Re: GE-Pittsfield/Housatonic River Site
Former Oxbow Areas A and C (GECD410)
Former Oxbow Areas J and K (GECD420)
Lyman Street Area (GECD430) – Properties West of Lyman Street
Addendum to Supplemental Information Package

Revised Vegetation Restoration Plan – Former Oxbow Areas A and C

REVISED VEGETATION RESTORATION PLAN FOR FORMER OXBOW AREAS A AND C

Remediation Planting Plan for Former Oxbow Areas A & C (Dwg. No. 06-05-09-AC)

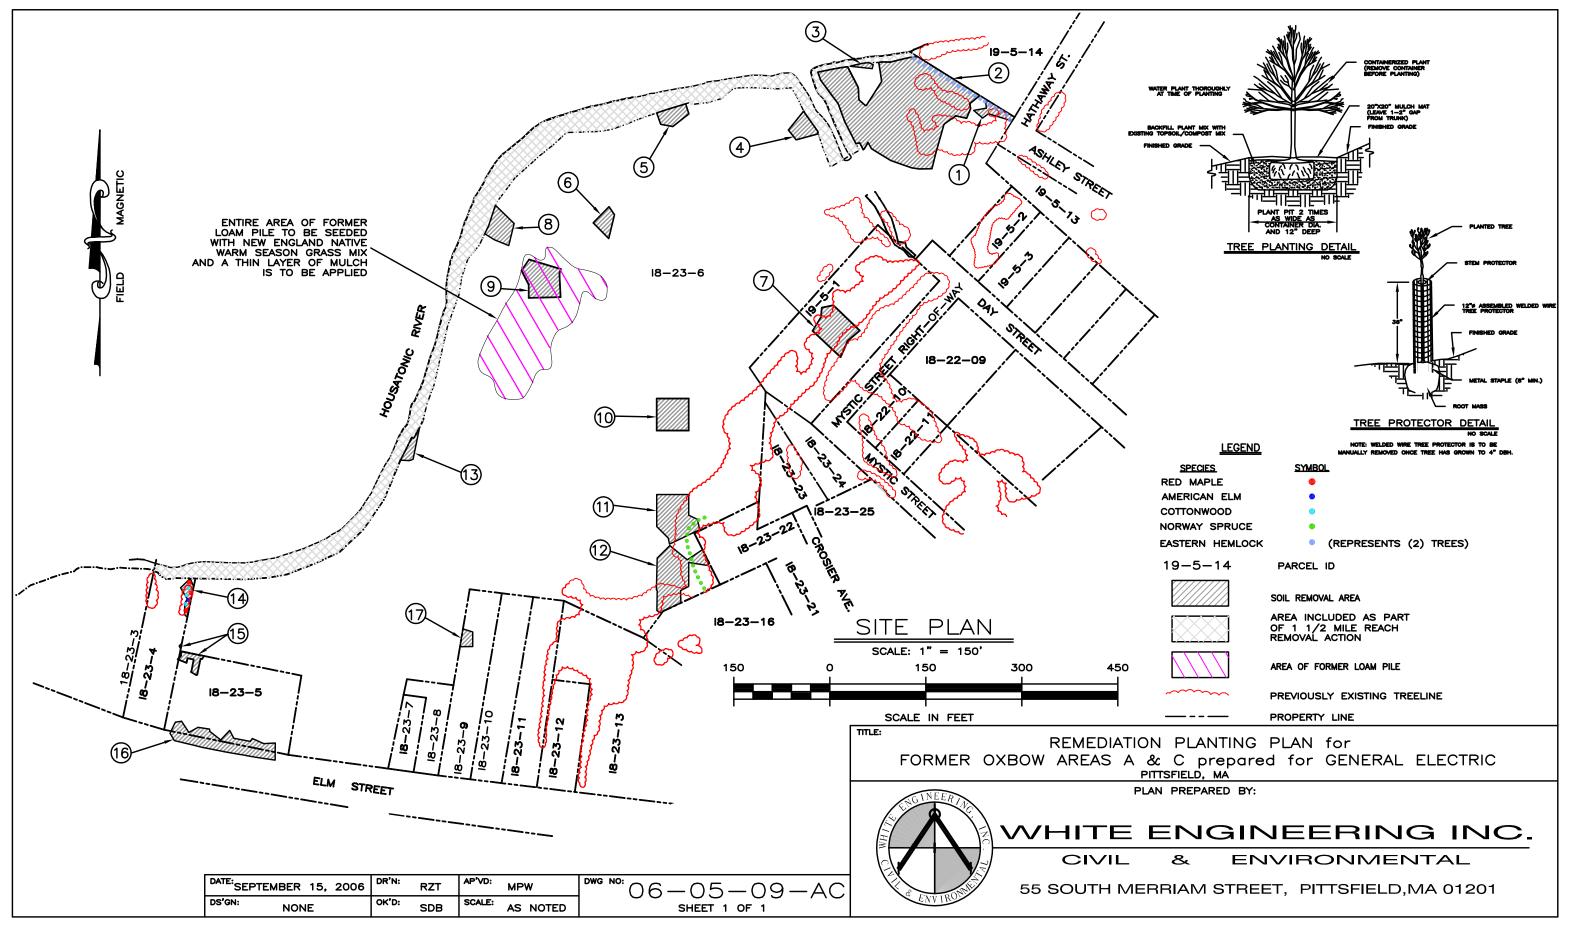
• <u>Planting Area # 1 and # 2</u>: A contiguous row of 38 Eastern Hemlock trees approximately 6 feet in height will be planted in these areas parallel to the boundary with Parcel I9-5-14 from the Housatonic riverbank to Hathaway Street, rather than planting the Box Elders originally proposed for these areas.

- <u>Planting Area # 7</u>: No trees will be planted in this area, as opposed to the original proposal for planting 14 Box Elders and 4 American Elms. However, this area will be seeded with warm-weather grass seed mix and mulched, as previously proposed.
- <u>Planting Area # 9</u>: No trees will be planted in this area, as opposed to the original proposal for planting 7 Box Elders and 5 Eastern Cottonwoods. Rather, the entire area of the former loam pile will be seeded and mulched.
- <u>Planting Area # 11 and # 12</u>: Fourteen Spruce trees approximately 8 to 10 feet in height will be planted in these areas, as shown in Attachment 1, in lieu of the trees previously proposed.
- Planting Area # 14: No changes to the original plan.

Planting Area: # 1 and # 2

Proposed Species and #: 38 Eastern Hemlock (Tsuga canadensis) 6 ft in height

To be planted parallel to Parcel I9-5-14 from the Housatonic riverbank to Hathaway Street

Planting Area: # 11 and # 12 Planting Area: 8,060 SF Total

Proposed Species and #: 14 Norway Spruce (Picea abies) 8-10 ft in height

Remediation Planting Plan for Former Oxbow Areas J & K (Dwg. No. 06-05-09-JK)

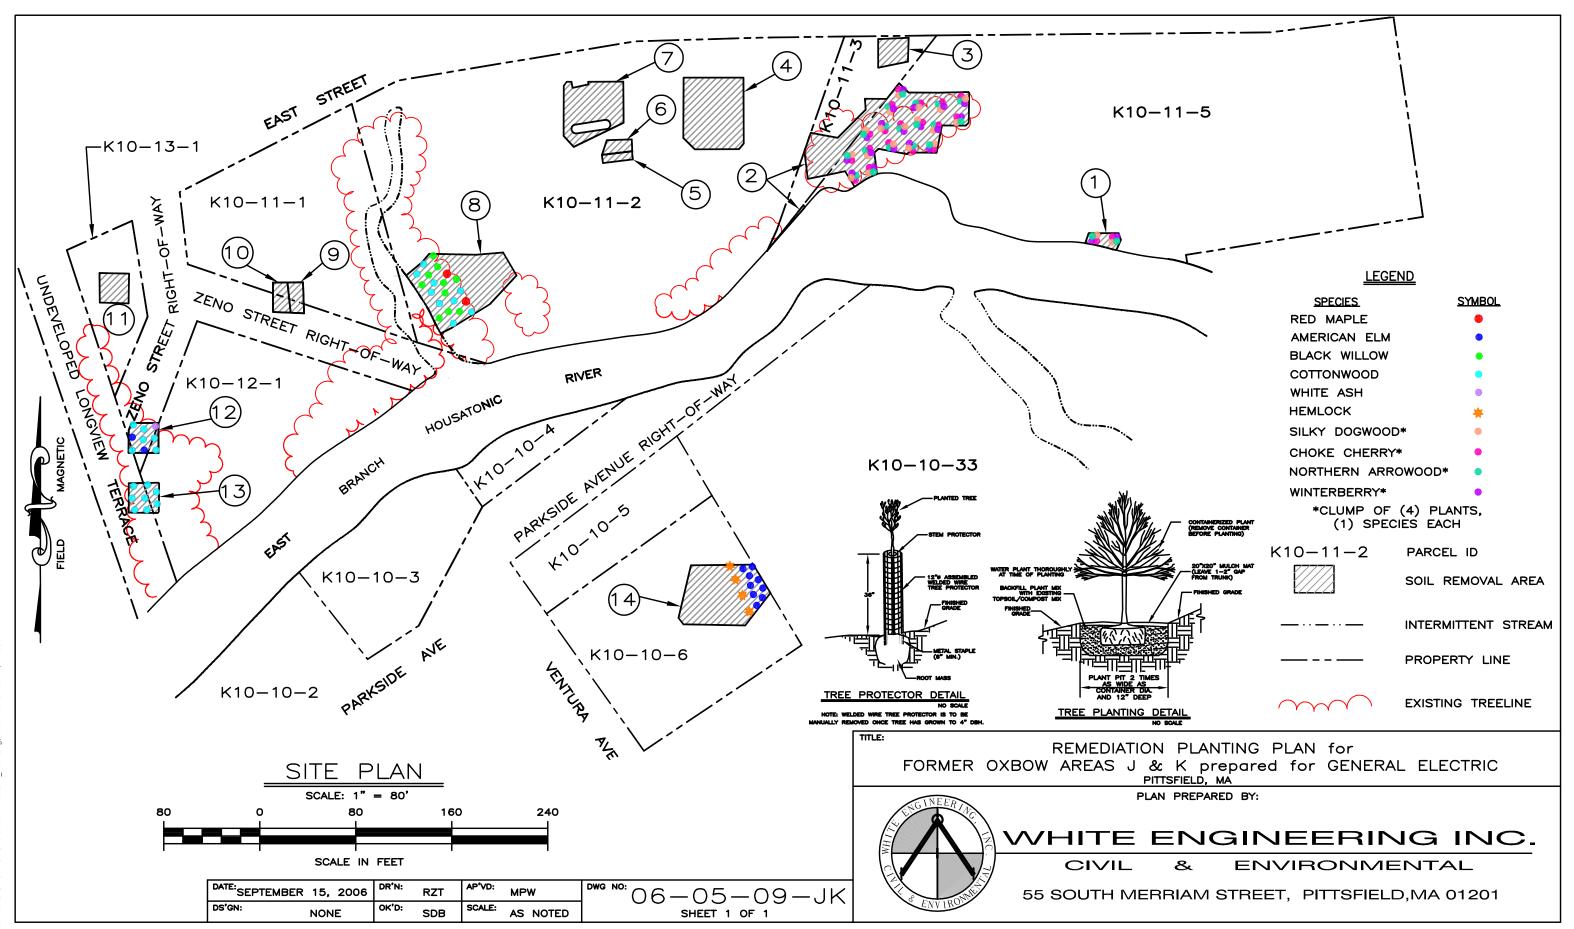
The only change from the Vegetation Restoration Plan for Former Oxbow Areas J and K (which was Attachment D to the SIP) relates to Planting Area # 2. Based on discussions with the owner of a property in this area, no trees or shrubs will be planted on Parcel K10-11-3. Rather than planting 22 shrub clusters (consisting of Silky Dogwood, Winterberry, Choke Cherry, and Northern Arrowwood) as previously proposed, 18 shrub clusters will be planted within Parcel K10-11-5 only. GE notified EPA of these revisions verbally, and obtained verbal approval from EPA of these revisions. The revised Vegetation Restoration Plan for Former Oxbow Areas J and K is provided as Attachment 2 to this letter. Remediation at Former Oxbow Areas J and K has been completed. The revised vegetation restoration activities will be implemented shortly.

GE's proposed planting plan will also involve the planting of a total of 20 clumps of shrubs (with 4 plants in each clump) in those areas where shrubs previously existed (except on Parcel K10-11-3, based on discussions with the owner of that parcel). This will include the planting of 2 clumps of shrubs in Area # 1 and 18 clumps in Area # 2, as shown on the attached work sheets for those areas.

Planting Area: # 2 (within Parcel K10-11-5 only)
